STAFF REPORT AMENDED 6-28-84
CITY PLANNING COMMISSION

- APPLICATION:
- A. Negative Declaration
 - B. Rezone 5± acres from R-1 to R-1A (Sec. 13)
 - C. Tentative Map (Subdivision Ord.)
 - D. Special Permit to develop 18 zero lot line units (Sec. 7)

APPLC. NO. P-84-176

TENTATIVE MAP
MEADOWVALE ESTATES
A PORTION OF THE SW 1/4 SEC. 6
T7N R5E MDM
CITY OF SACRAMENTO, CALIFORNIA
APRIL 1984 SCALE: 1"=40'

STAFF EXHIBIT

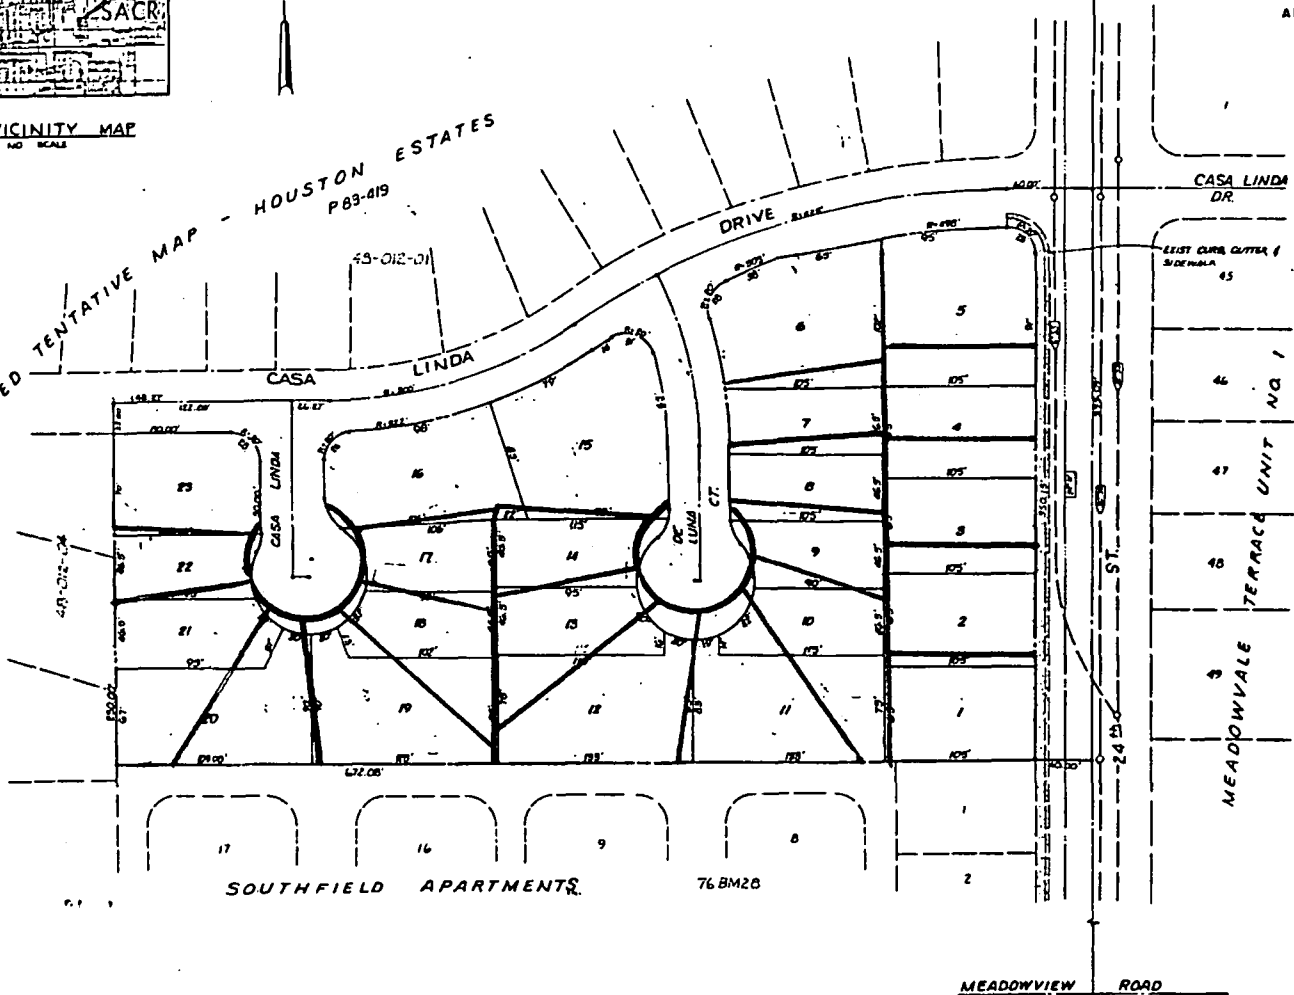
- C. The applicant has modified the Tentative Map from the one originally submitted. The revised map and plans were developed to address staff's concern over the driveways in the cul de sacs and on the lots fronting on 24th Street. As originally proposed, the lots within the cul de sacs were to be developed with the driveway located on the property line and little or no separation between driveways. The site design of the lots fronting on 24th Street indicated that back out driveways would be provided, which is not consistent with the design criteria for lots fronting on a major street. The applicants revisions have eliminated three lots and addresses some of staffs concern over the driveways in the site design. Staff does, however, recommend some minor revisions to the plan. Staff recommends the lots fronting on 24th Street be increased to a width of 70 feet which is consistent with the proposed design criteria for lots fronting on a major street. The additional width is also more desirable for the proposed circular driveways. The additional width can be provided to these lots by reducing the depth of the corner lot on 24th Street and Casa Linda Drive by 20 feet. The 20 foot reduction will not reduce the corner lot below the minimum lot size of 6200 square feet for corner lots. In addition, to this modification, staff recommends the property lines of the lots located within the cul de sacs be straightened. This can be accomplished by reducing the length of the cul de sacs and increasing the depth of the lots at the rear of the cul de sac. (see attached staffs Exhibit A)

- X 6. The applicant shall submit revised plans which reflect a minimum lot width of 70 feet for those lots fronting on 24th Street. The revised plans shall also be designed so that the property lines of the lots within the cul-de-sacs are straightened in a manner similar to the attached staff's Exhibit A. Revised plans shall be submitted to the Planning Director for review and approval prior to filing a final map. (added by staff)

1. The applicant shall submit revised plans which reflect a minimum lot width of 70 feet for those lots fronting on 24th Street. The revised plans shall also be designed so that the property lines of the lots within the cul de sacs are straightened in a manner similar to the attached staffs Exhibit A. Revised plans shall be submitted to the Planning Director for review and approval prior to filing a final map.
